Subject: River Bend Station
Docket No. 50-458
License No. NPF-47
Additional Information Related to License Amendment
License Amendment Request (LAR) 99-15, Changes to Technical Specifications
for Power Uprate of River Bend Station

Response to NRC Questions Related to River Bend Station Power Uprate Amendment

Enclosure 2
Response to NRC Questions Related to River Bend Station Power Uprate Amendment
(TAC NO.MA6185)

Summary Of Plots

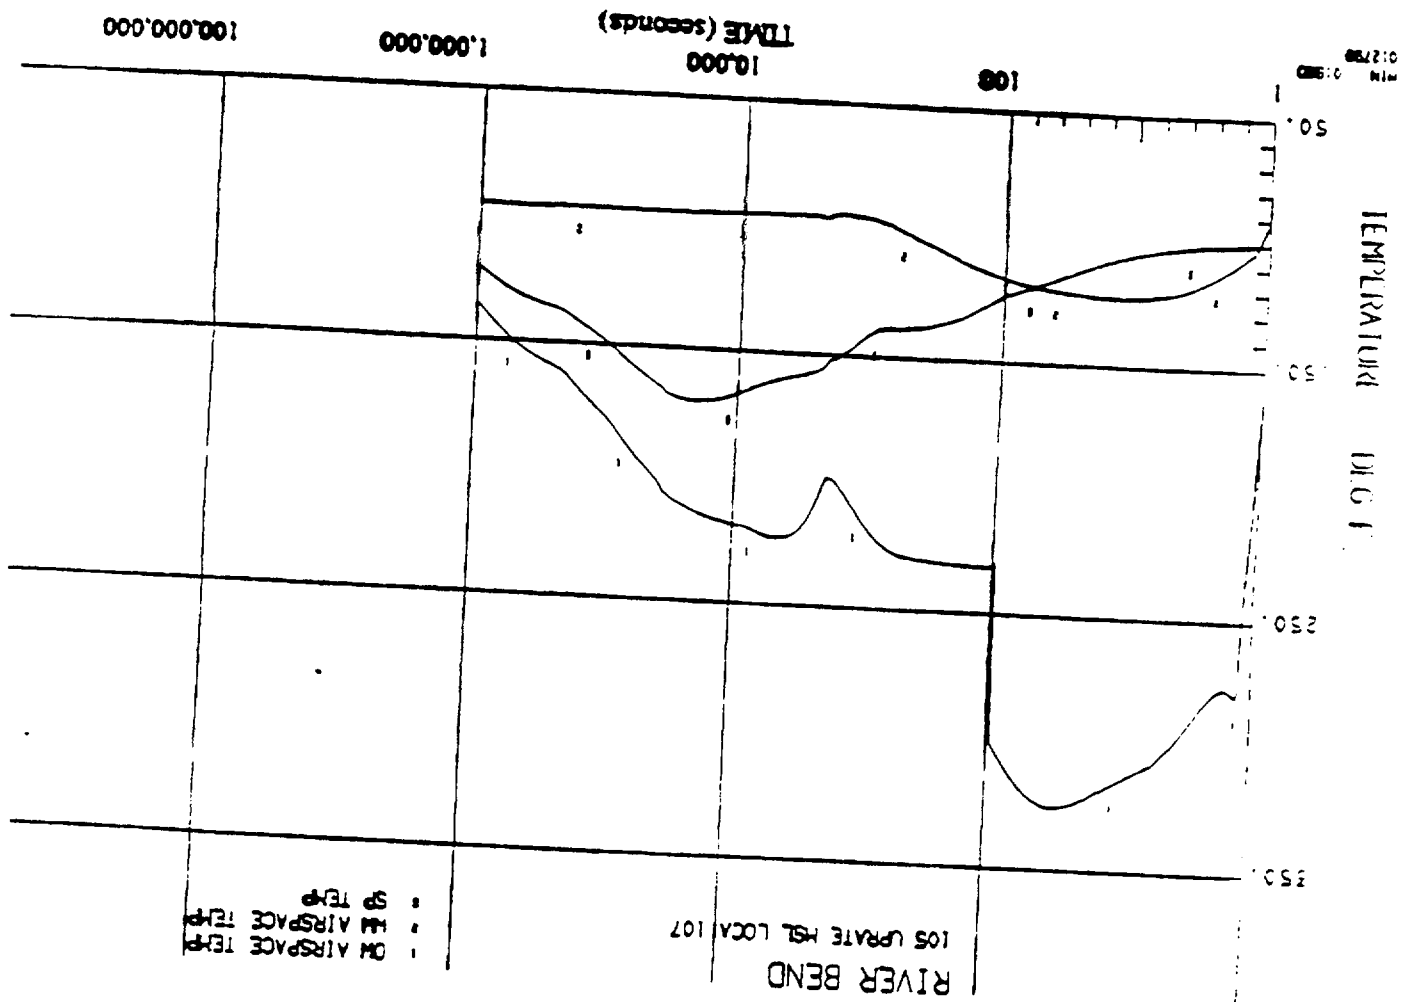
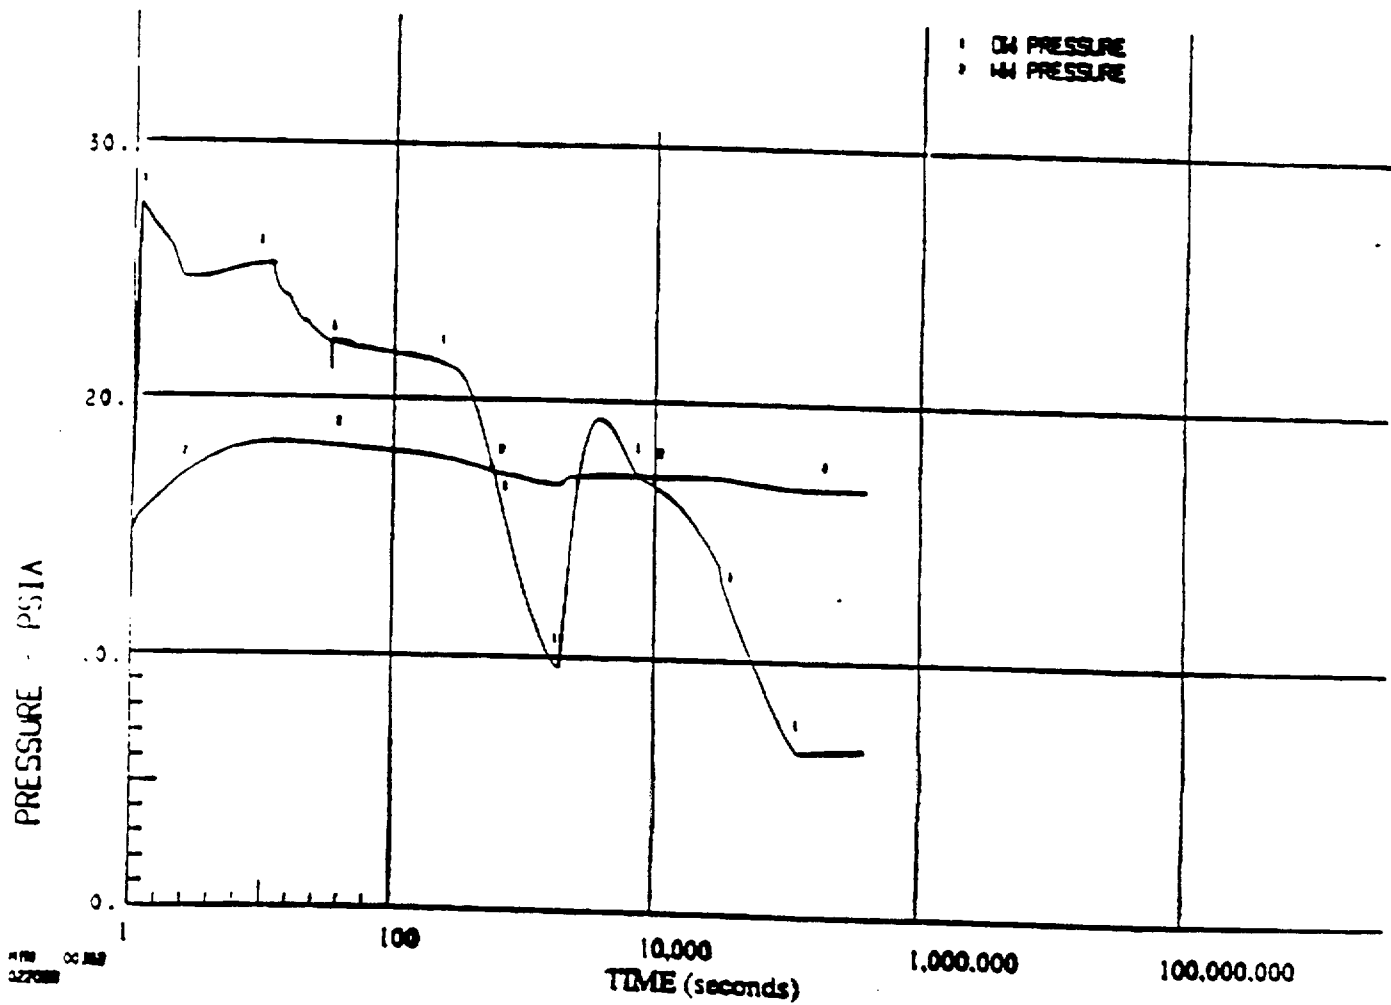
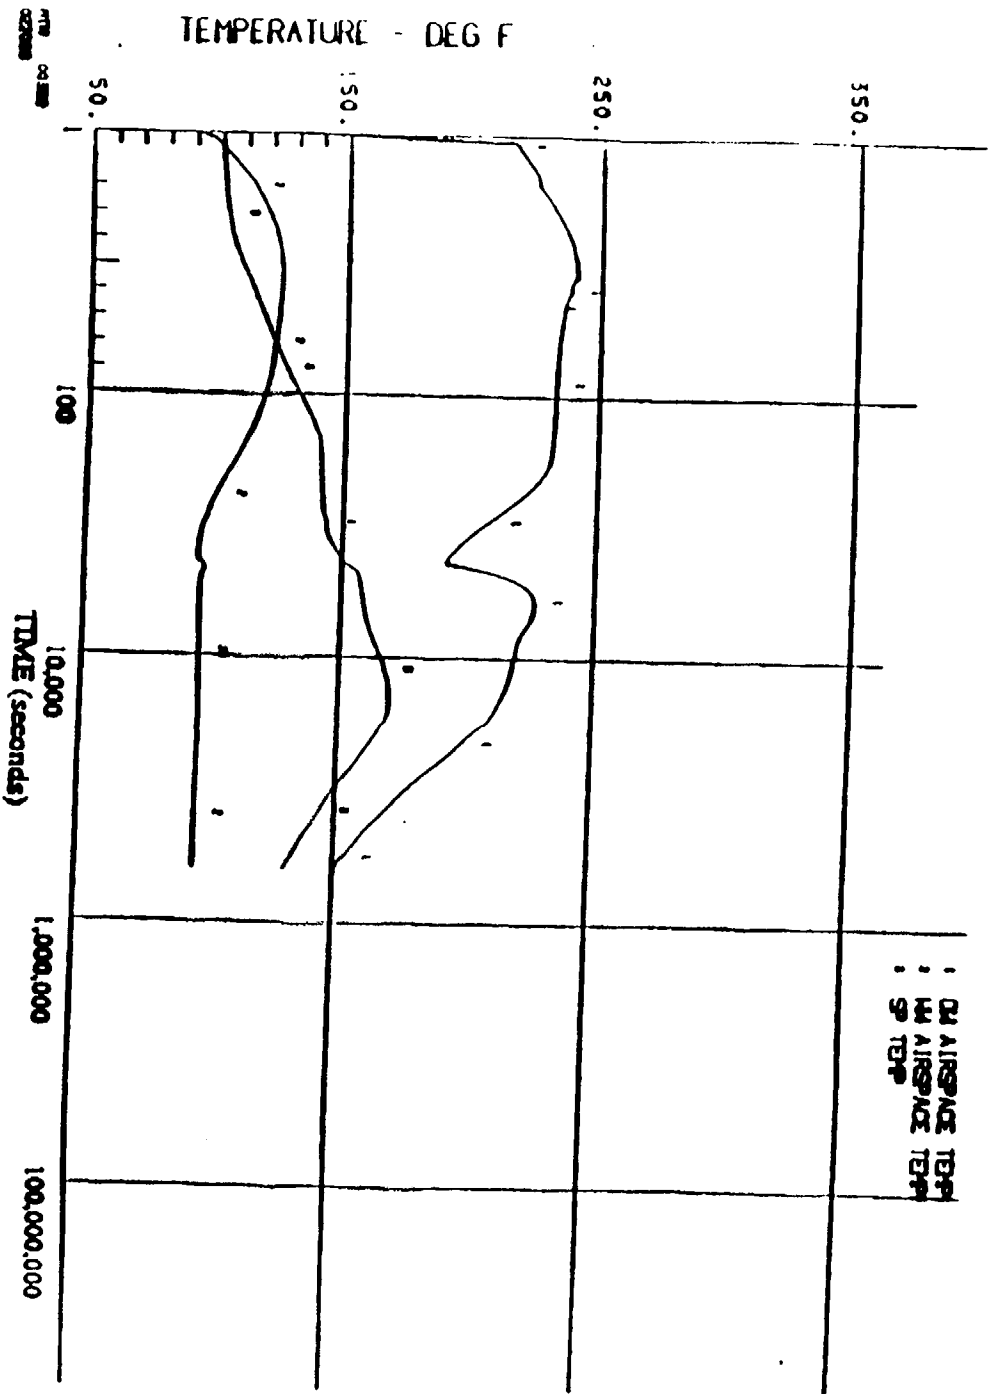
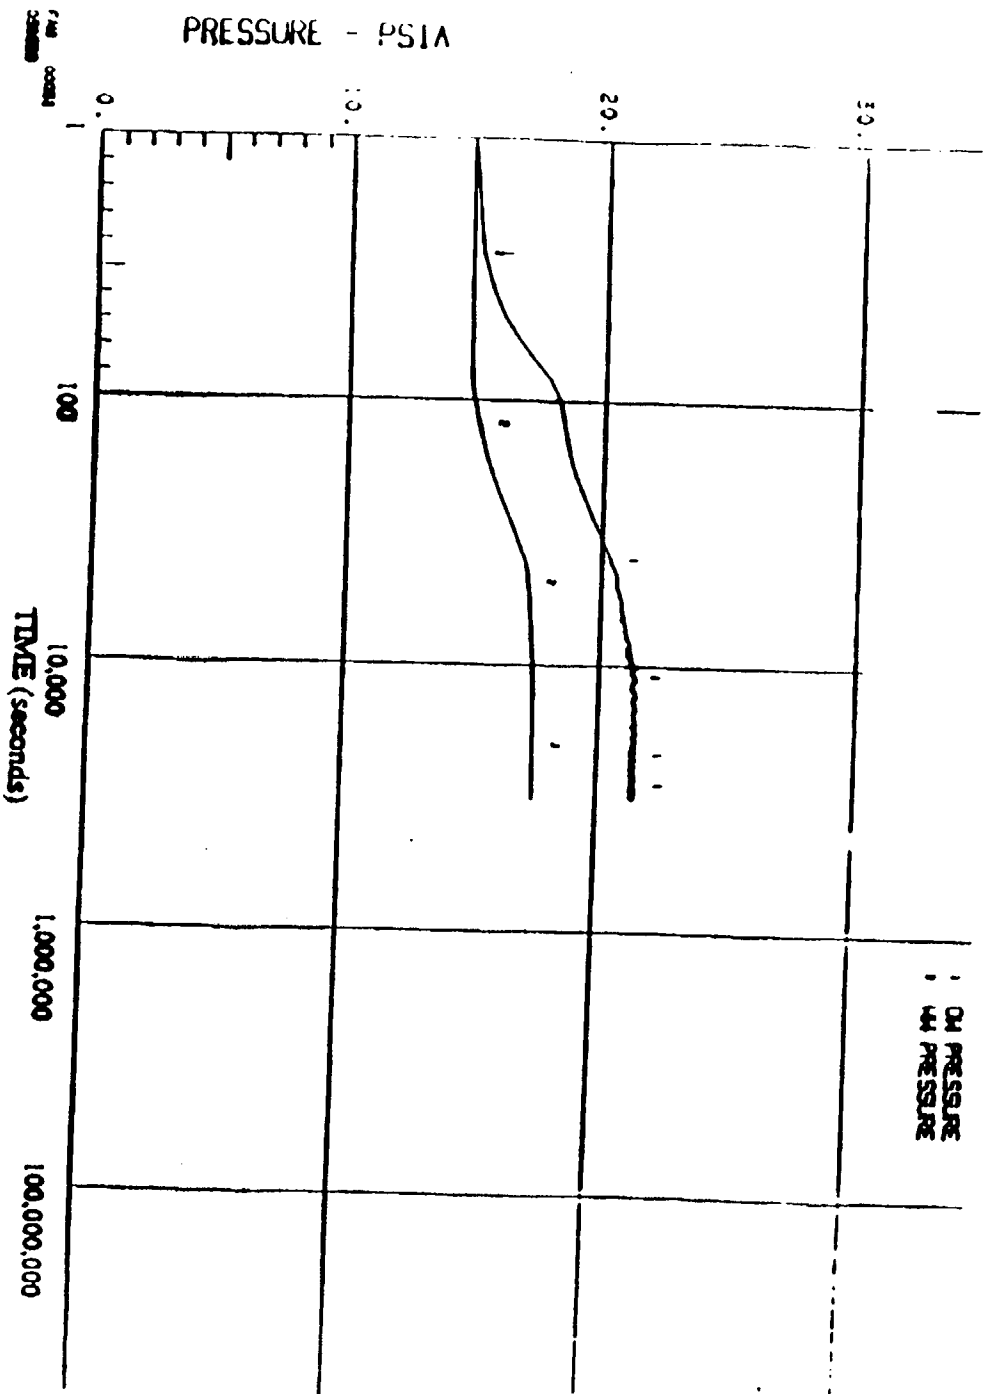
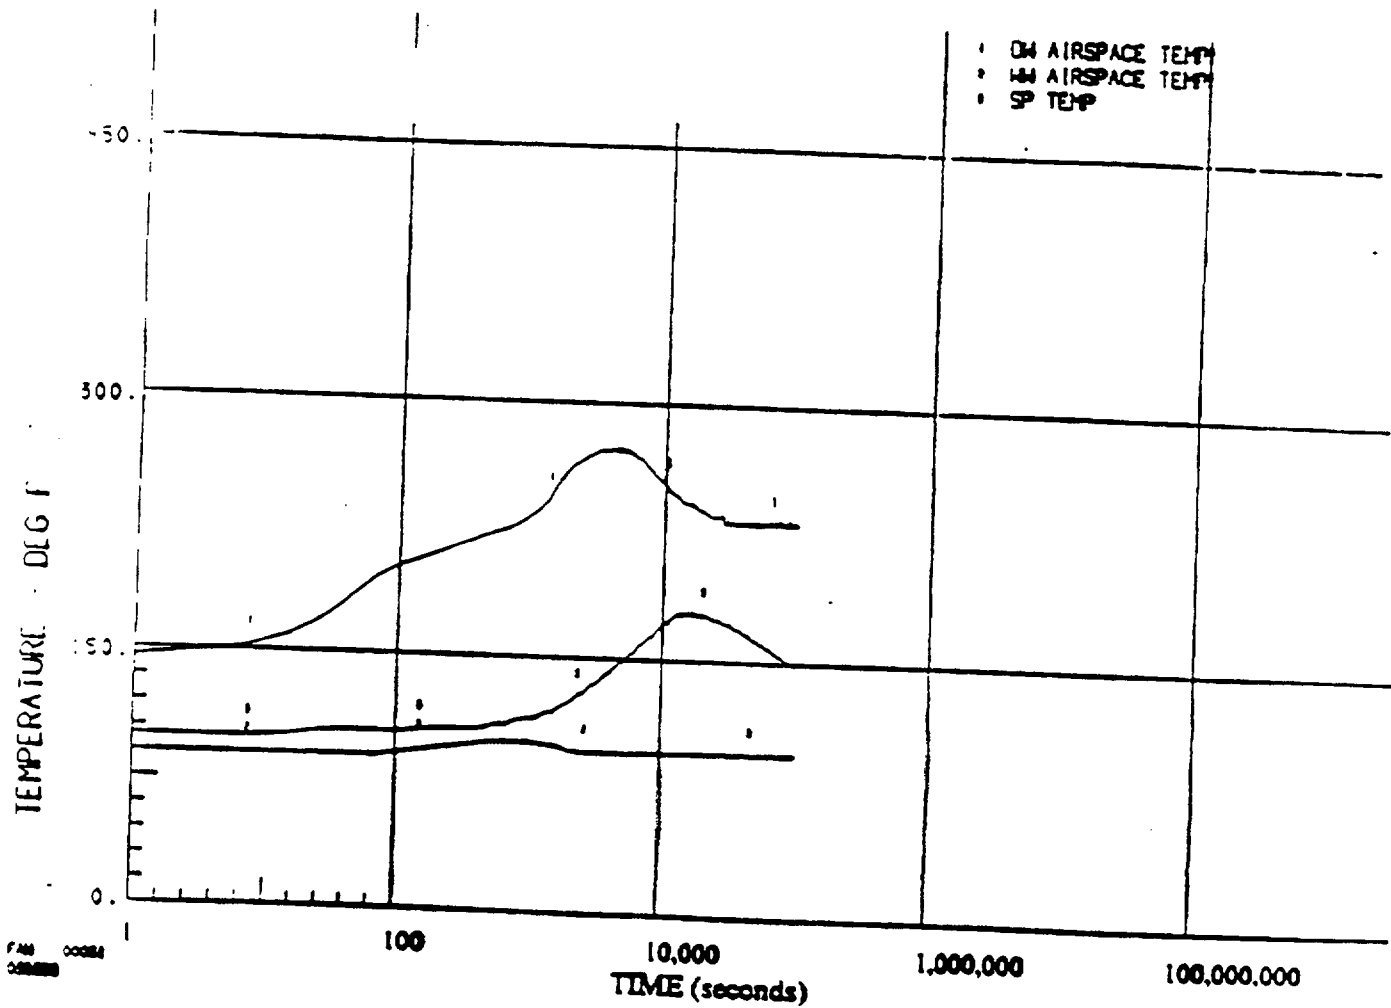
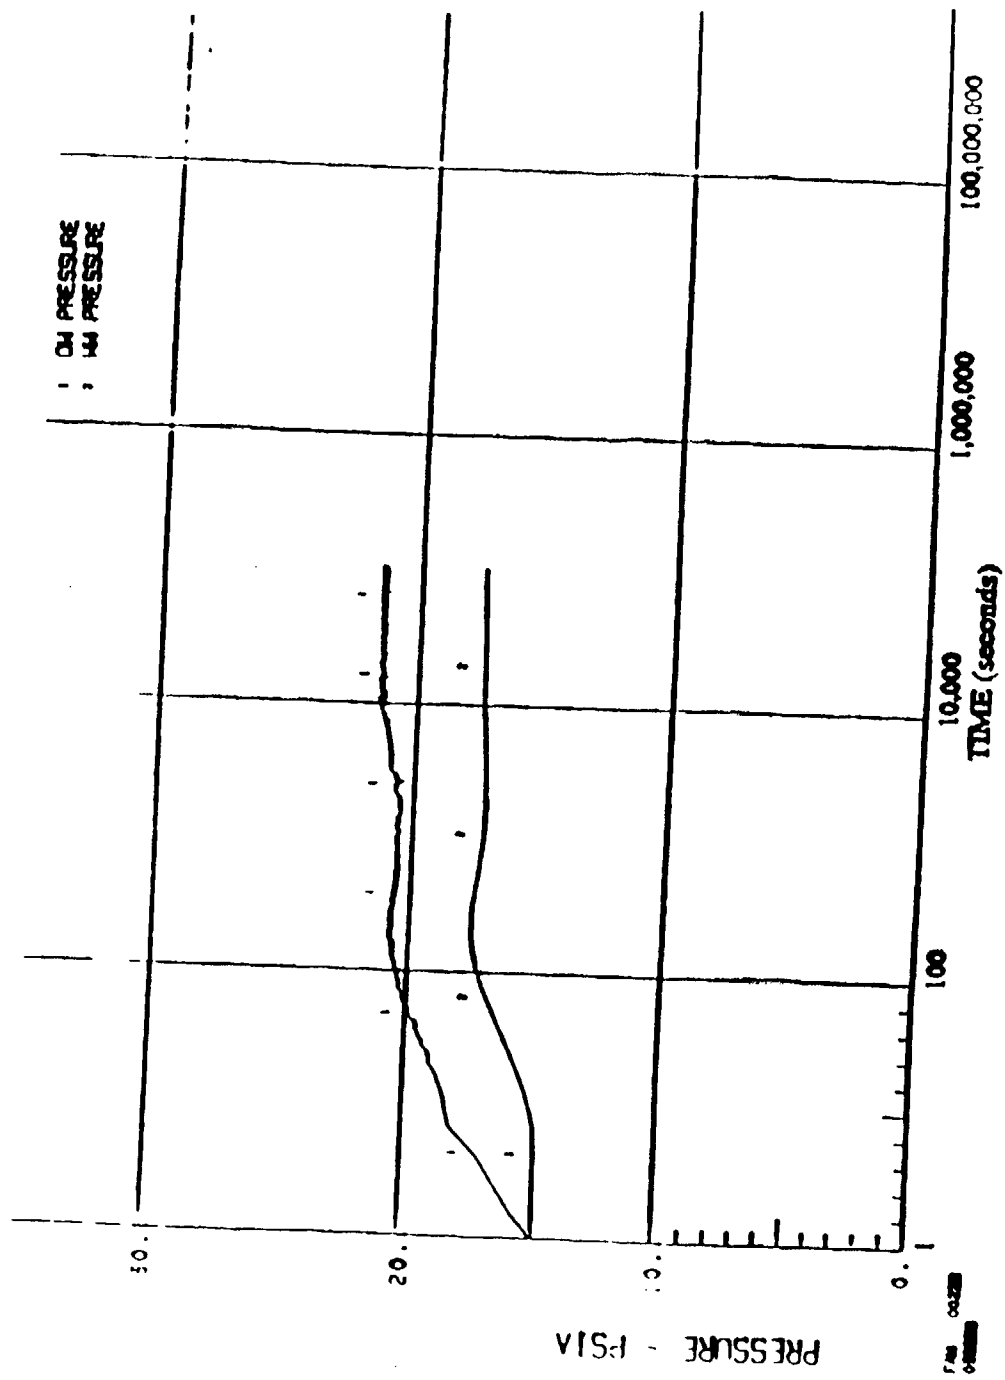
Question 5: Please provide the containment analyses maximum pressure and temperature curves at uprated power after a LOCA. Discuss the limiting initial conditions assumed for the DBA LOCA and for the sensitivity case for the MSLB for peak drywell pressure as indicated in Section 4 1.1.3. Also provide the containment drywell pressure limit in psig.

Response 5: Drywell & Containment Pressure Temperature Plots are attached at the end of this response. Please note that these figures are considered GE proprietary information. The original USAR analysis was based upon a nominal set of initial conditions. These results were supplemented by a sensitivity analysis to establish the range of acceptable conditions for the containment (Technical Specifications 3.6.1.4, 3.6.1.5, 3.6.2.1, 3.6.5.4, and 3.6.5.5). The following table summarizes the initial conditions, and key results for the nominal case, and significant sensitivities.

In the table above, the peak drywell temperature is shown to exceed the design limit by approximately 3 °F. This is discussed in Section 4.1.1.3 of NEDC-32778P. The computer program used to calculate the short term response does not include the impact of heat sinks on the temperature rise. If heat sinks are considered, the peak drywell temperature will not exceed 330 °F.

The current value of P_a used for containment testing is 7.6 psig, and is based upon the containment response assuming Technical Specification initial conditions. This value of P_a bounds the peak containment pressure calculated for uprate. Therefore, the value of P_a for containment testing will remain 7.6 psig.
